**Share Food Program  
Delaware County Warehouse Renovation  
General Construction - Request for Proposals  
Addendum #2**

**ADDENDUM NO. 2**

**DATE:** November 21, 2022

**RE:** Share Food Program - Delaware County Warehouse Renovation

**7** WINDOW DETAIL  
SCALE: 1-1/2" = 1'-0"

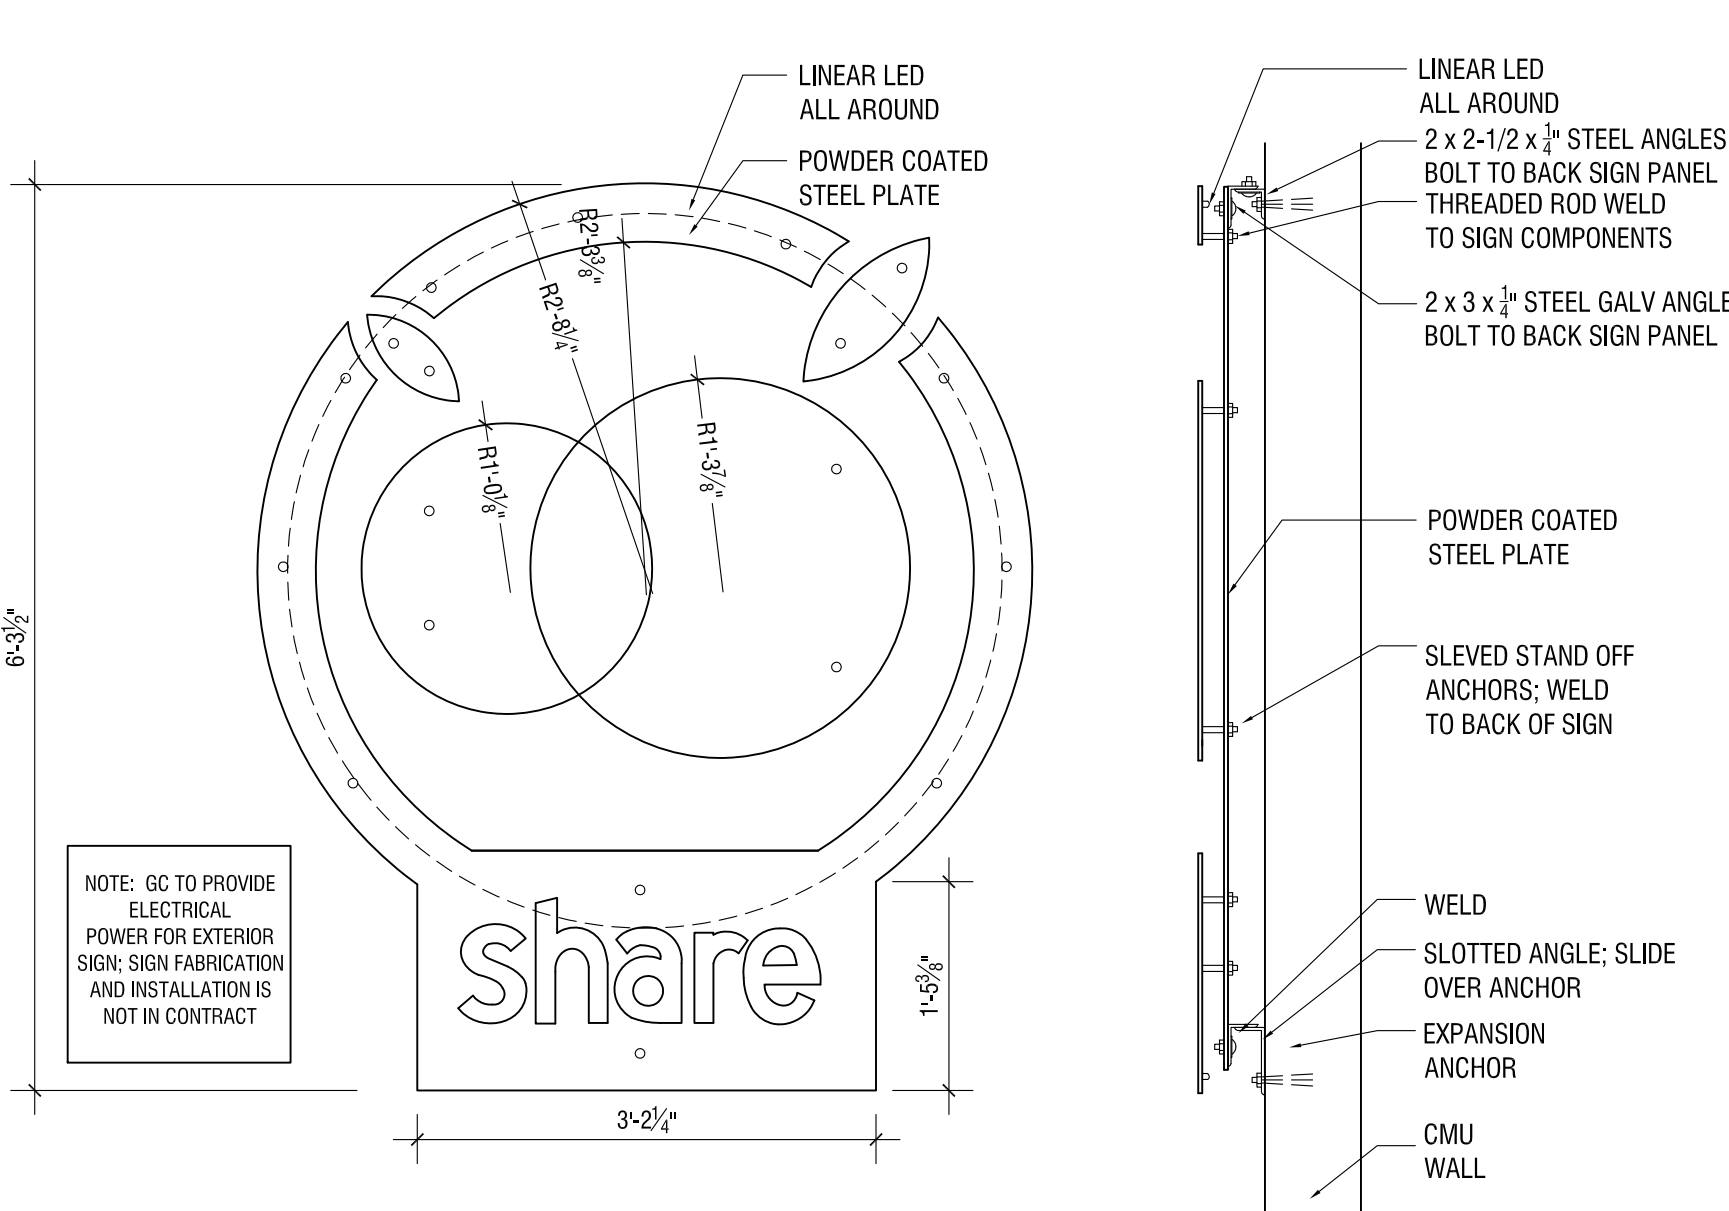
Remove and replace drawing -C0 Dated 11/15/2021 and replace it with drawing C-0 Dated 11/21/2022. Clarified paving location on Site Plan, paving details 8 & 9, added HM window detail 7.

Answer: See above.
11. Question: Confirm raised platform in the north east section the building is to be removed (see attached)  
Answer: see above.
12. Question: Provide window header, jamb, and material details for frame types 3 and, in office 101 as shown on A-1

Answer: See Detail 7/C-0.
13. Question: Detail 2/A1 indicates a foundation drain, please provide site plan showing

SHEET NAME:  
SELECTIVE  
DEMOLITION  
PLANS

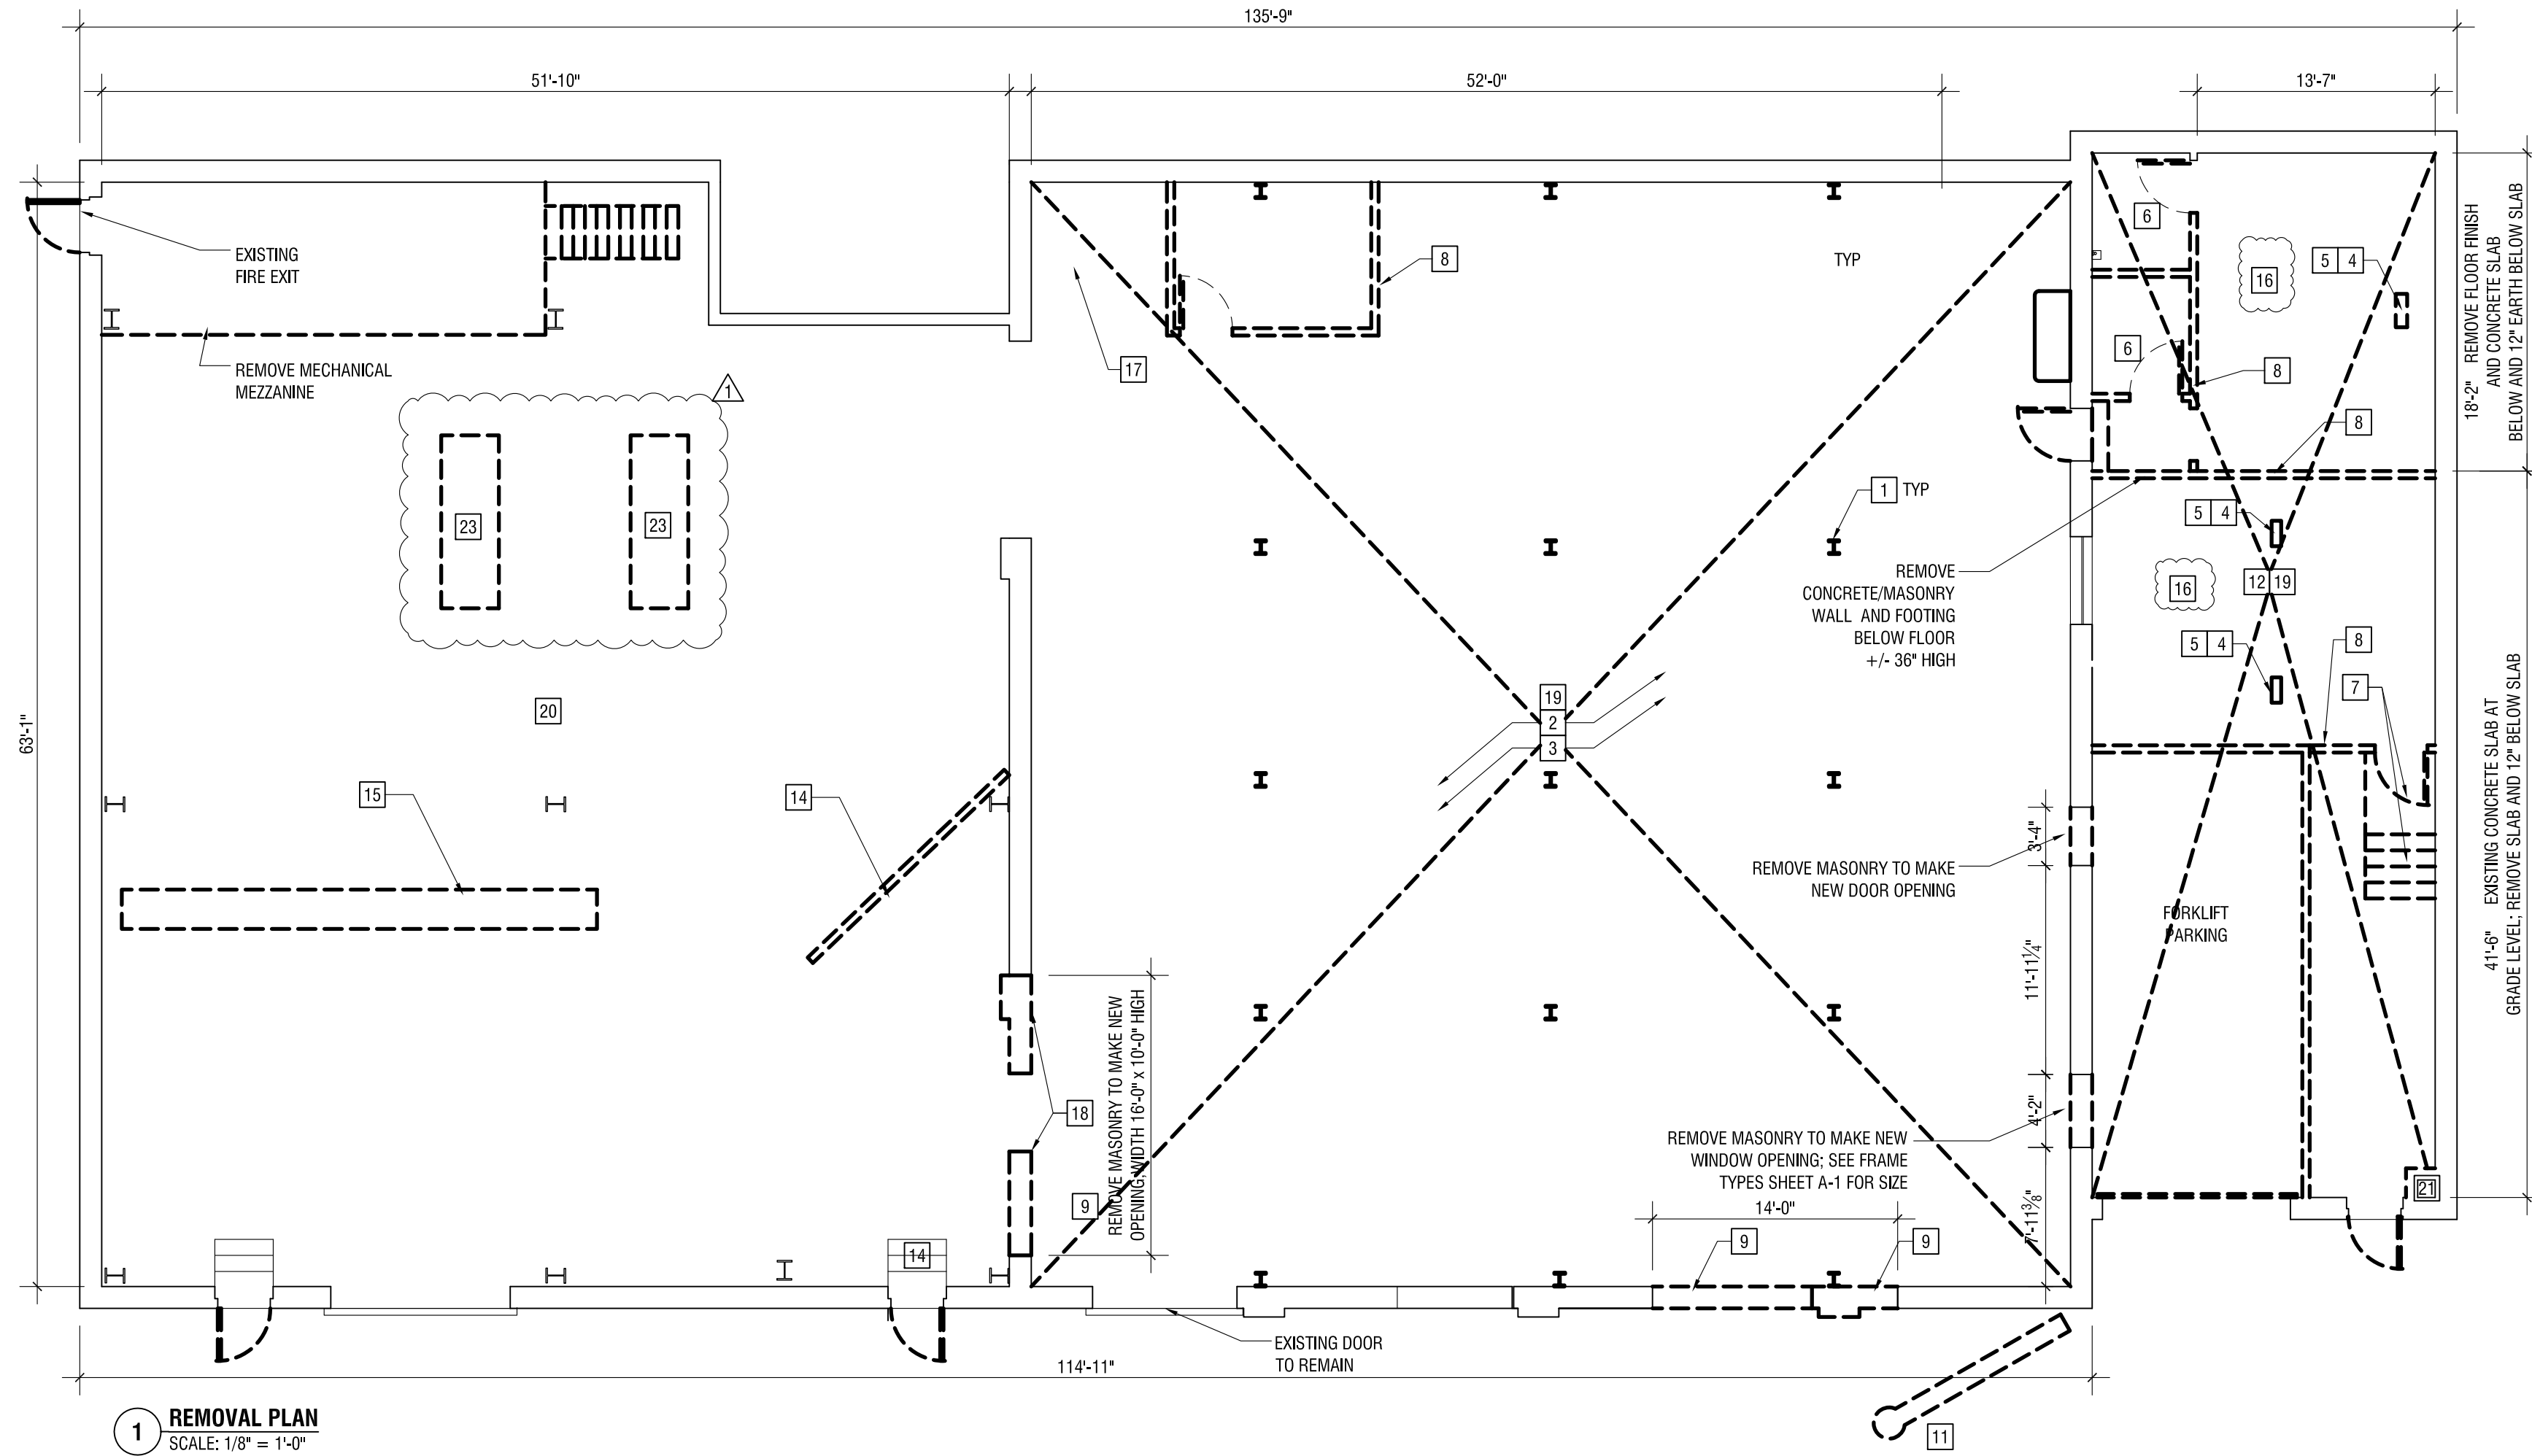
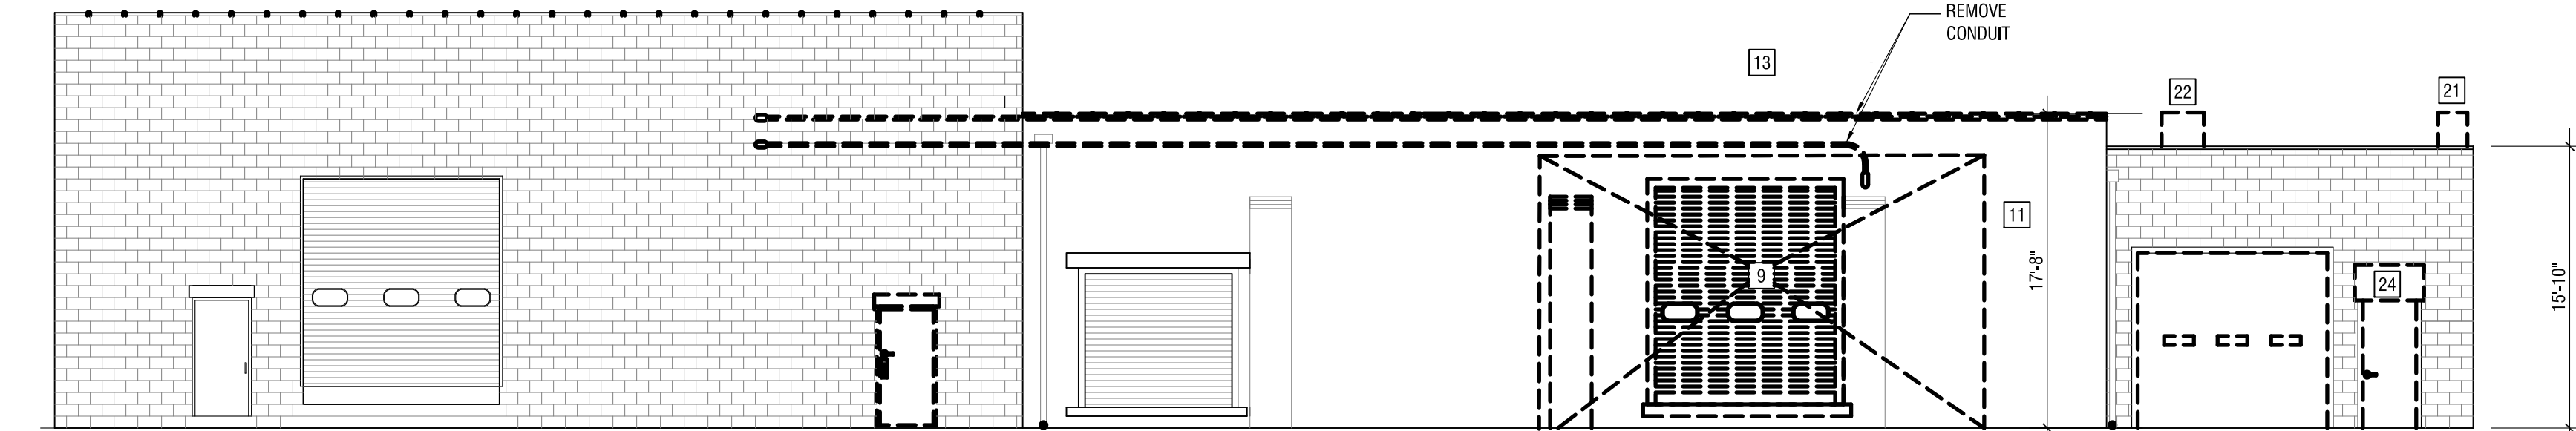
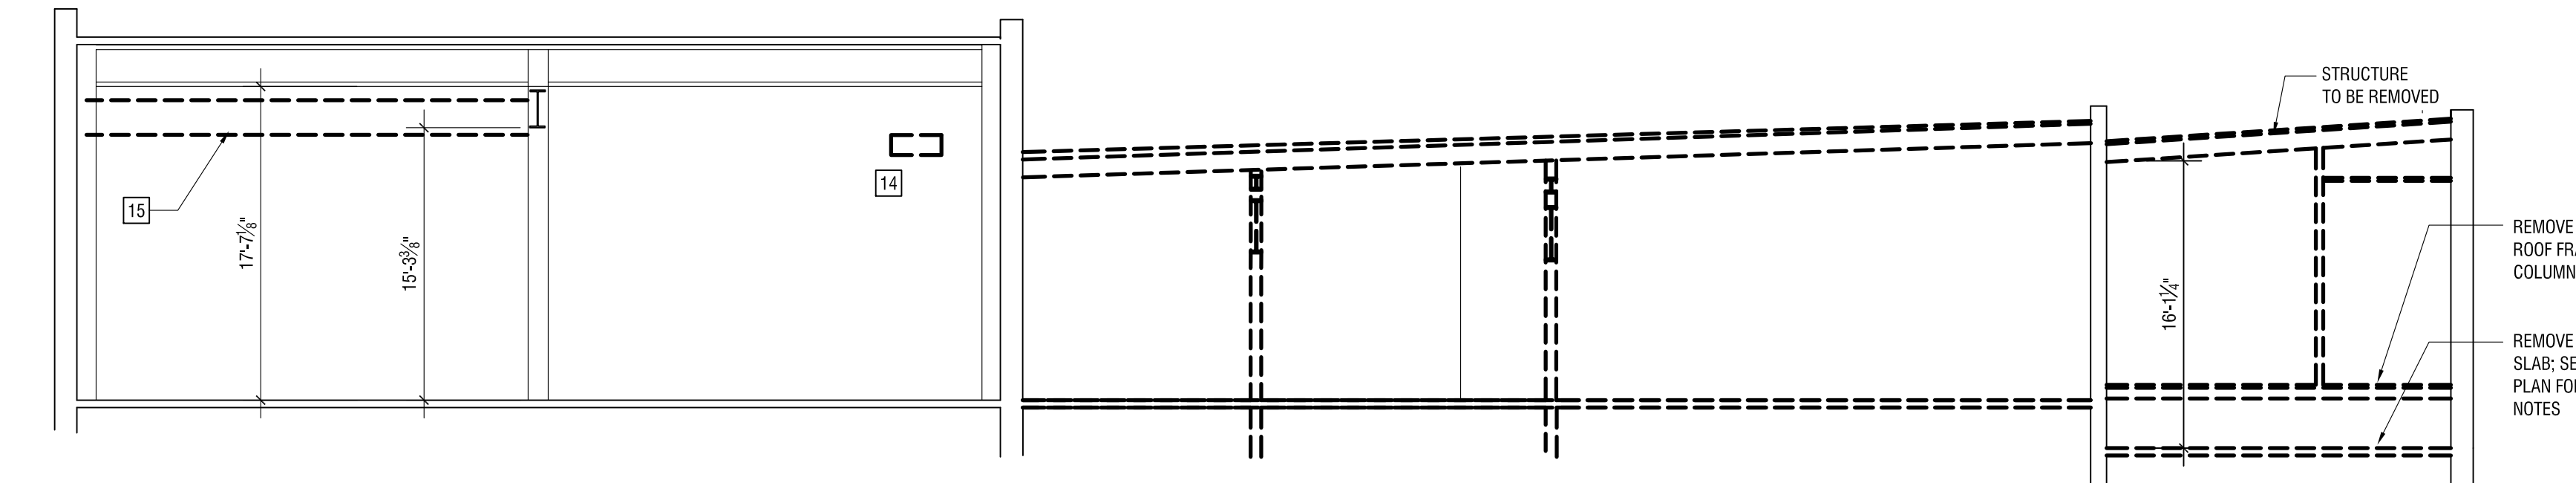
Remove and replace drawing D-1 Dated 11/15/2021 and replace it with drawing D-1 Dated 11/21/2022. Revised removal note 16 and clarified removal scope drawings 2 & 4.

Answer: Infill wall with 6" CMU installed flush with warehouse side.
9. Question: Please indicate where Removal Note 16 on D-1 applies on the plans  
Answer: Duplicate note removed from Drawing 1/D-1. We changed note 16 to clarify that the removal scope includes a concrete slab PLUS wood floor and floor joists over framed in those rooms.

10. Question: Note 18 'Remove existing Lintel, Masonry to make new enlarged opening' does not apply on north east area of the D-1. Confirm exclusion. (See attached)
